MB3712 transistor replacement with new low frequency Amplifier Reb. Ass'y

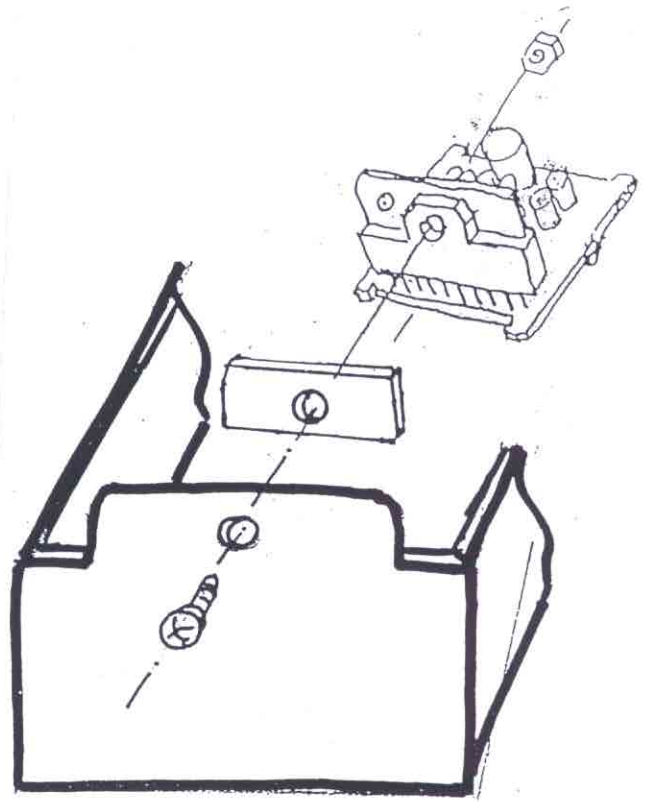
1. Remove 2 x MB3712
2. Drill the heatsink and screw the Reb. Ass'y t/w the wedge.
3. Connect the Reb. Ass'y and apply modifications as following:

- 1 - WHITE
- 2 - BLACK
- 3 - RED
- 4 - GREY
- 5 - VIOLET
- 6 - BROWN
